**ADDENDUM TO THE
FINAL WORK PLAN FOR
THE HYDROGEOLOGIC
INVESTIGATION OF THE
WATERVLIET ARSENAL**

Manhole 43

**RESPONSE TO EPA AND NYSDEC COMMENTS
MANHOLE 43, OIL WASTE LINE**

FIGURE 1

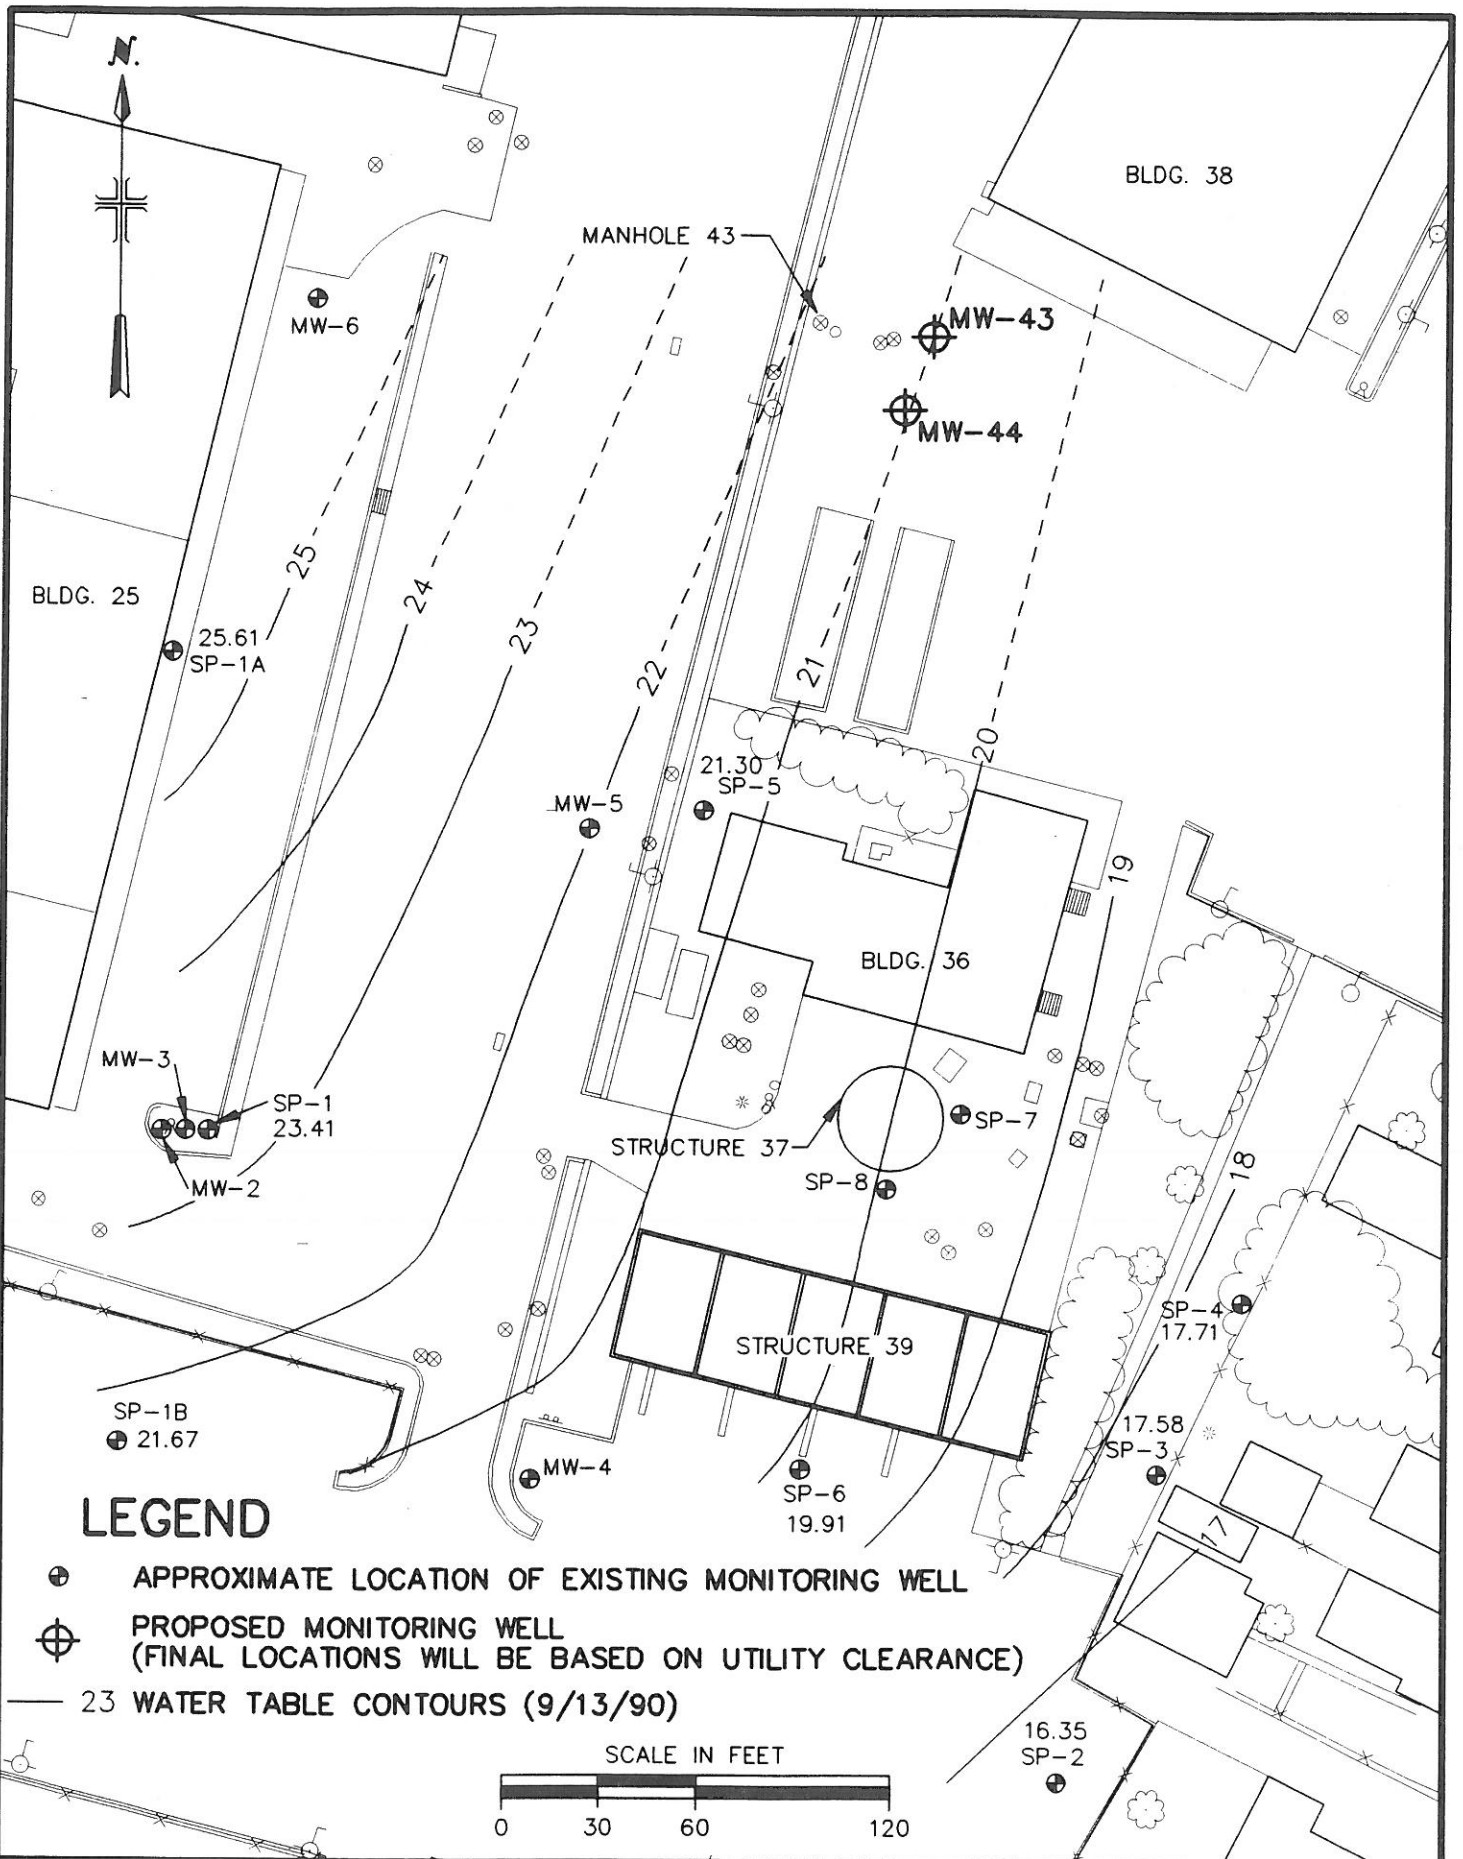
- Response 4. Soil samples will be collected from the monitoring well boreholes to be installed downgradient of Manhole 43 and the former excavation.
- Response 5. Groundwater quality will be characterized by analyses listed in the response to comment one. Hydraulic conductivity testing will be performed on each of the newly-installed monitoring wells to determine the hydraulic conductivity of the soils in the vicinity of each well. Existing monitoring wells in the vicinity of Manhole 43, such as 86EM-SP-5 and 95MPI-MW-6, will be used to determine the direction and gradient of groundwater flow in the vicinity of Manhole 43..

The investigation of the area around the waste oil line at Manhole 43 will involve the installation of two overburden monitoring wells. Based on the eastward flow of the groundwater towards the Hudson River, the monitoring wells will be located hydraulically downgradient of Manhole 43, i.e., east of the retaining wall, as shown on Figure 1. The locations of Manhole 43 and the proposed monitoring wells are shown on Figure 1.
